BZA #20382

Parties in Opposition

June 16, 2021

The Project is not in harmony with the general purpose and intent of the Zoning Regulations (11-X 901.2)

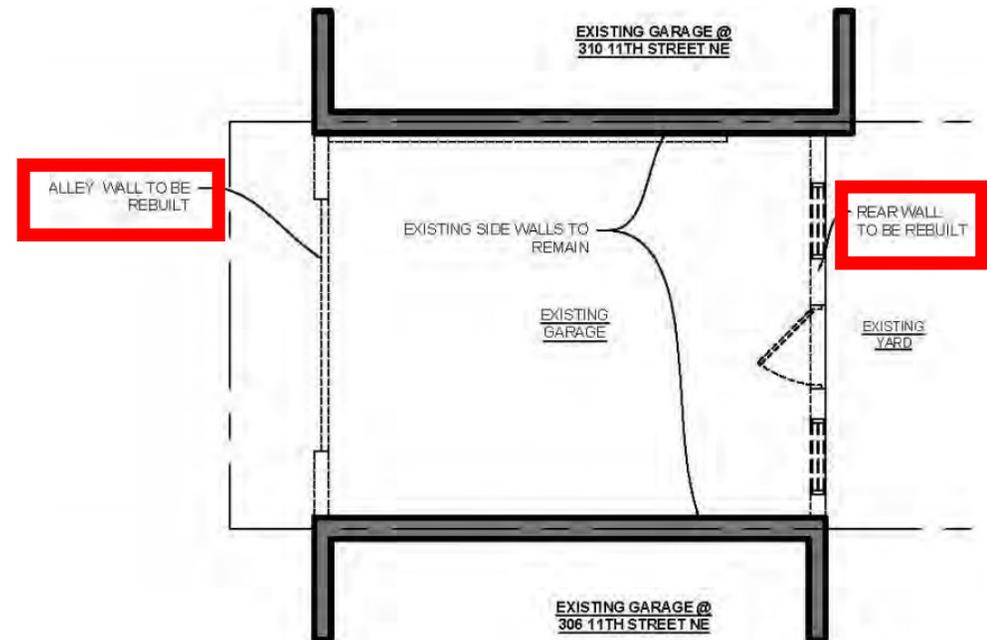
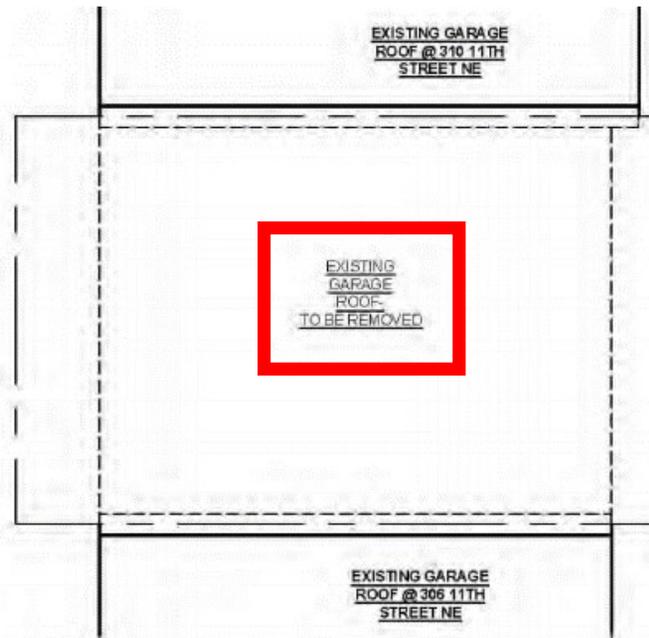
- Existing non-conforming garage will be demolished and replaced with a larger 2-level non-conforming garage.

The Project will adversely affect the use of the neighboring properties (11-X DCMR 901.2)

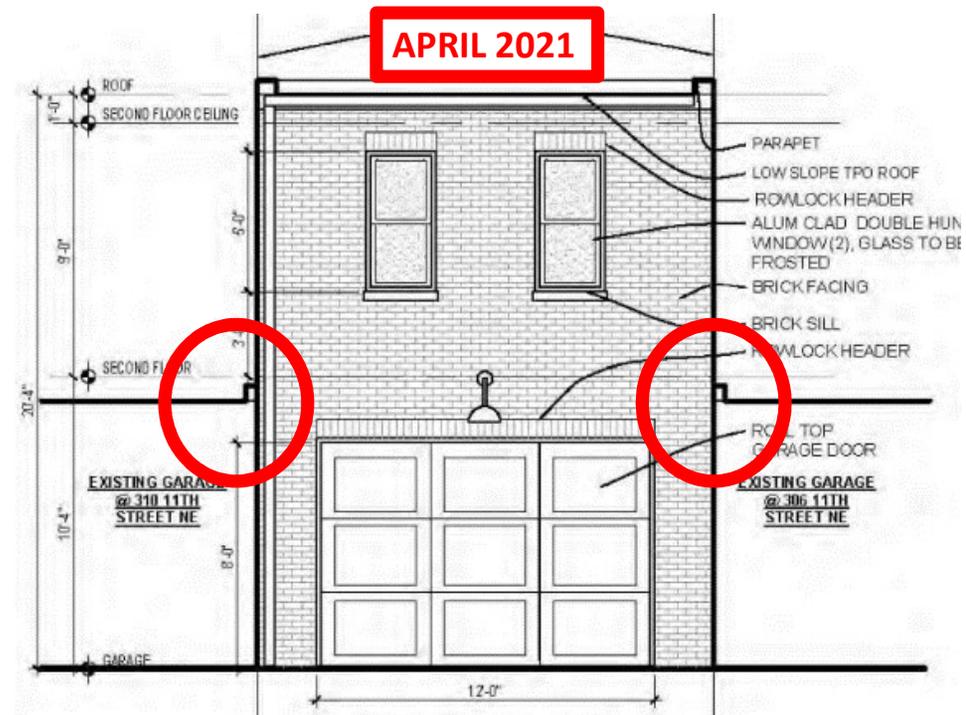
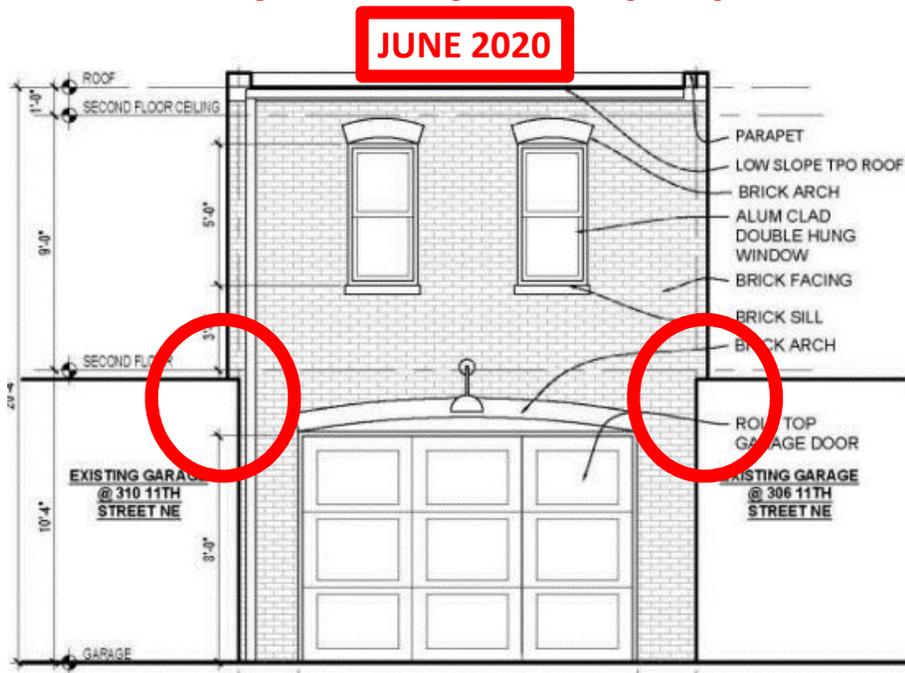
- May foreclose any future use and access to entire top of all party walls by the adjacent properties.

Significant UNDOE Intrusions into Privacy of Howell and Wilson Residences

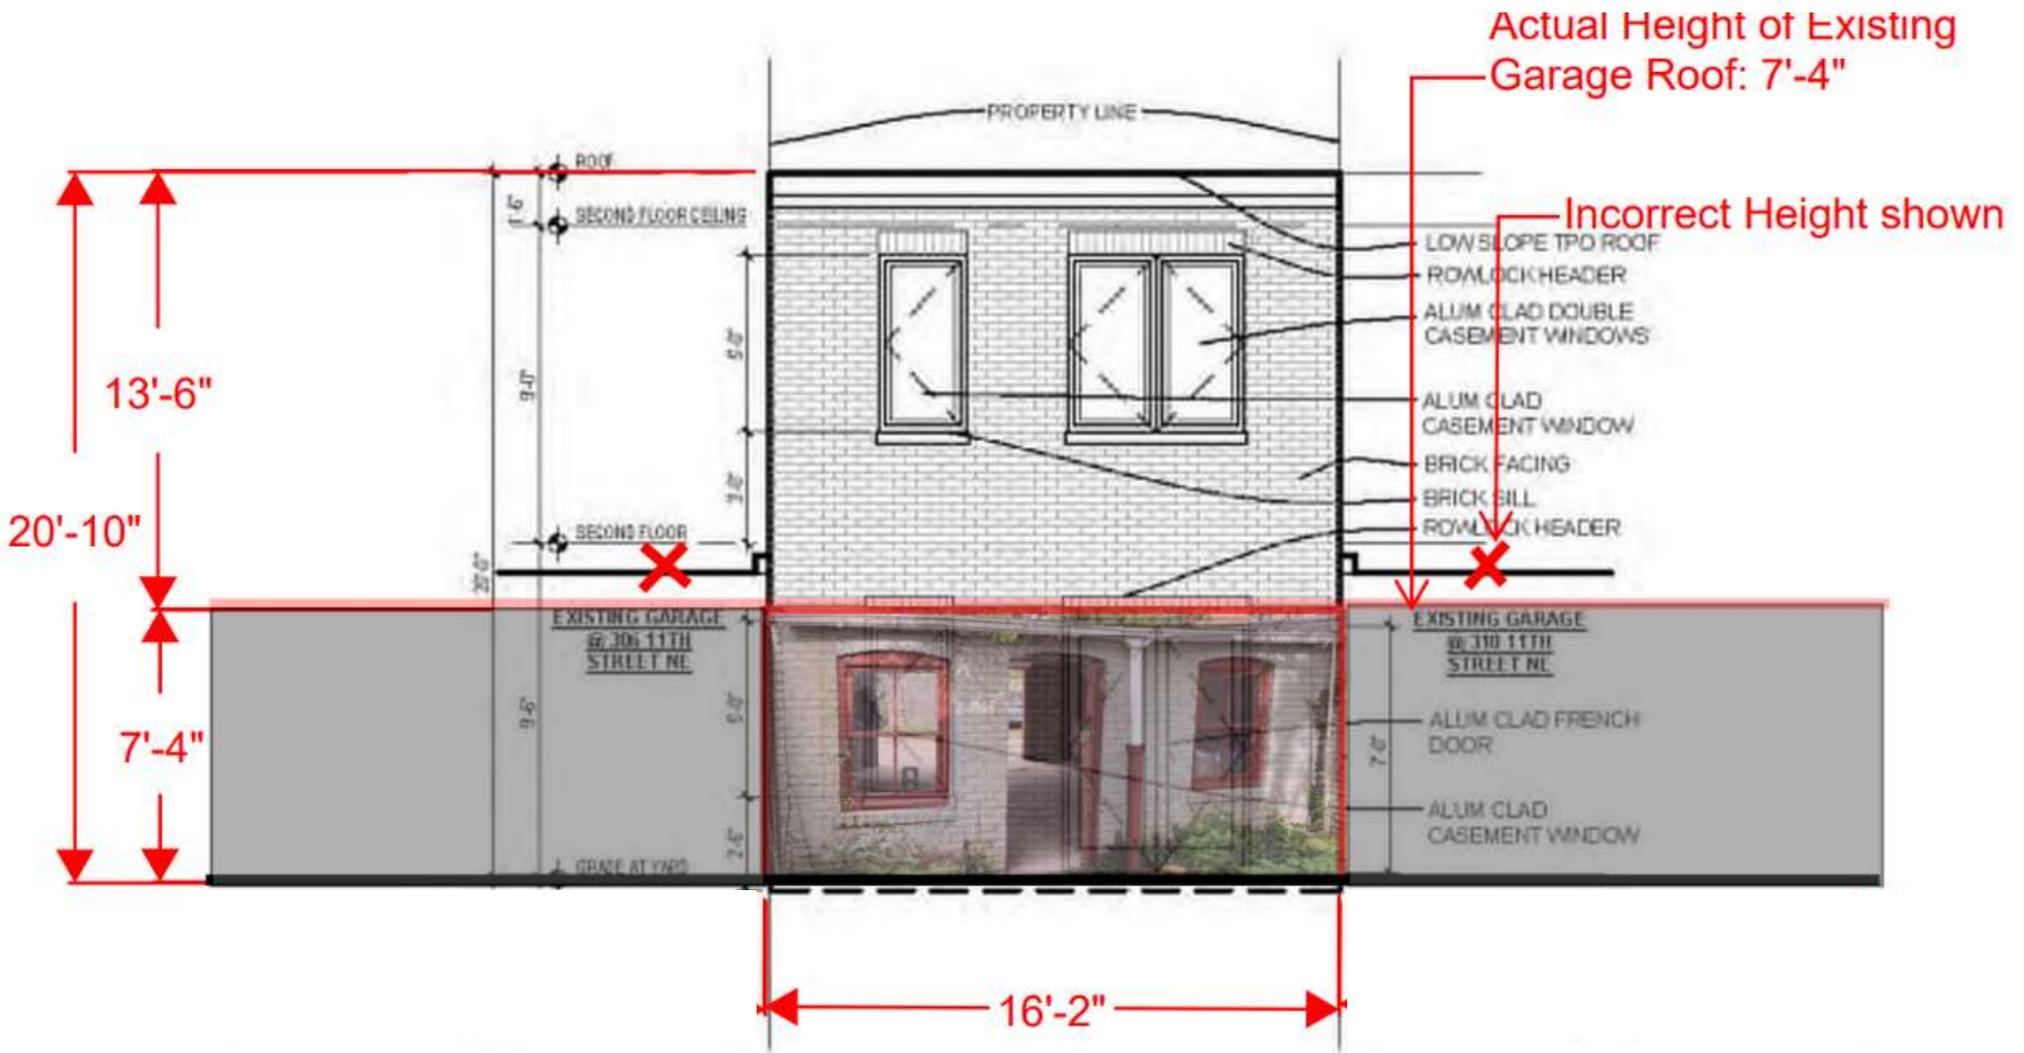
- Long, unfrosted east windows face directly into Wilson Residence and into Howell classroom, master bedroom, rear yard ONLY ~20 ft. away.
- Enlarged window on dogleg looks directly into the main bathroom of Wilson bathroom and children's bedroom.
- If use is as ADU, not just office, significantly heightens privacy concerns.
- **Applicant's recent modifications concede UNDO privacy, but benefit Applicant, not neighbors (Applicant frosted windows in bathroom and "nook") on alley. Not consistent with BZA precedent.**
- **ELECTRONIC FROSTING PROVIDES PRIVACY TO APPLICANT, NOT NEIGHBORS**
- BZA precedent on same alley required higher sills, smaller windows, frosted, for a 2nd level that is used solely as home office (no bathroom/water), and for a neighbor over 100 ft. away.
- Apartment includes two skylights in main living area.

Significant **UNDUE** affects on **AIR TEMPERATURES** and **AIR FLOW** to Howell Residence

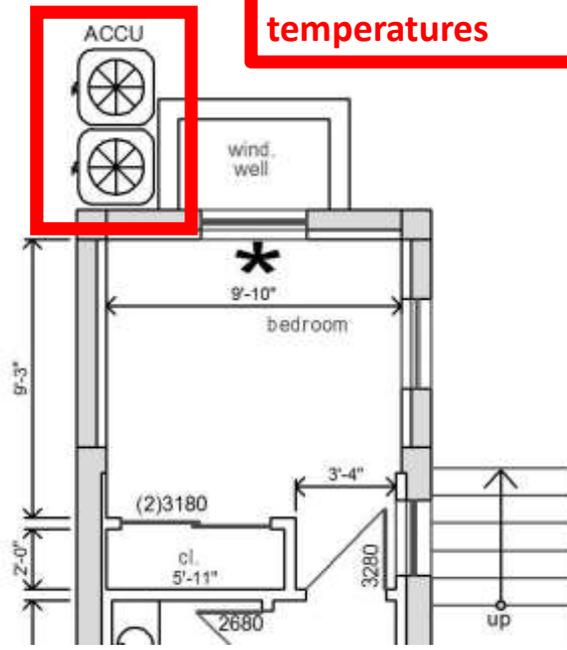
- 13 ft. high x 22 ft. long wall facing directly adjacent south onto Howell Residence and into rear yard will **UNDULY** increase air temperatures into Howell rear yard.
- 20 ft. high x 16 ft. long wall facing directly adjacent east onto Howell Residence will **UNDULY** increase air temperatures into Howell rear yard.
- Unduly increased air temperatures will be compounded by two new AC units placed directly adjacent to Howell property line. **NOTE: Applicant's statement that property will be single-family dwelling—B2007169 shows 2 AC units (e.g., will units be on same or separate electric meters?).**

Significant **UNDUE** affects on **AIR TEMPERATURES** and **AIR FLOW** to Howell Residence

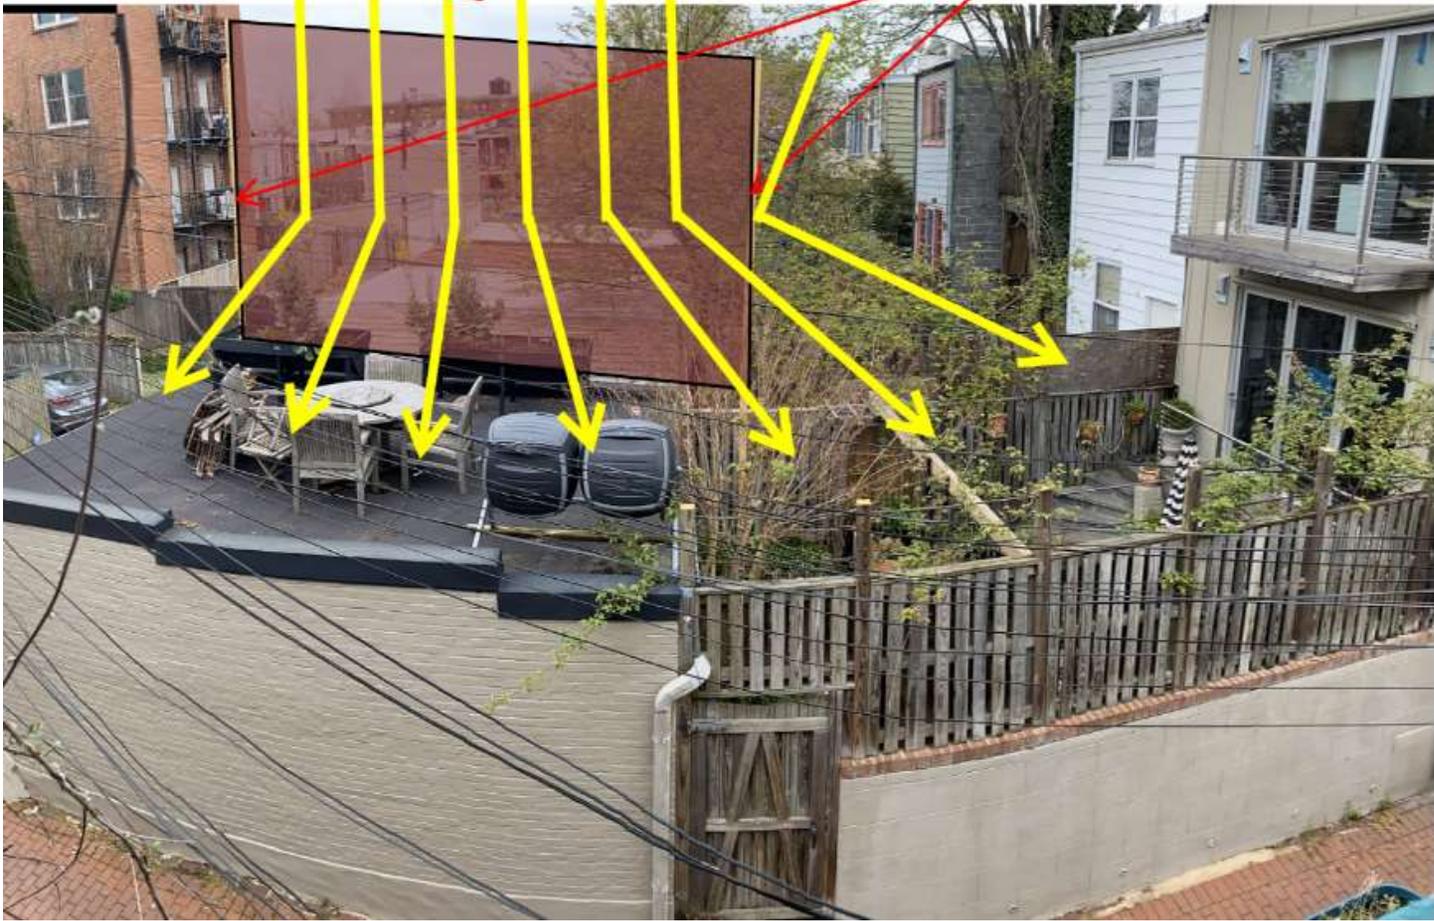
2 new AC units adjacent to Howell Residence will further increase air temperatures

10 to 15 degree increase in solar
Heat Gain from Reflected sun.
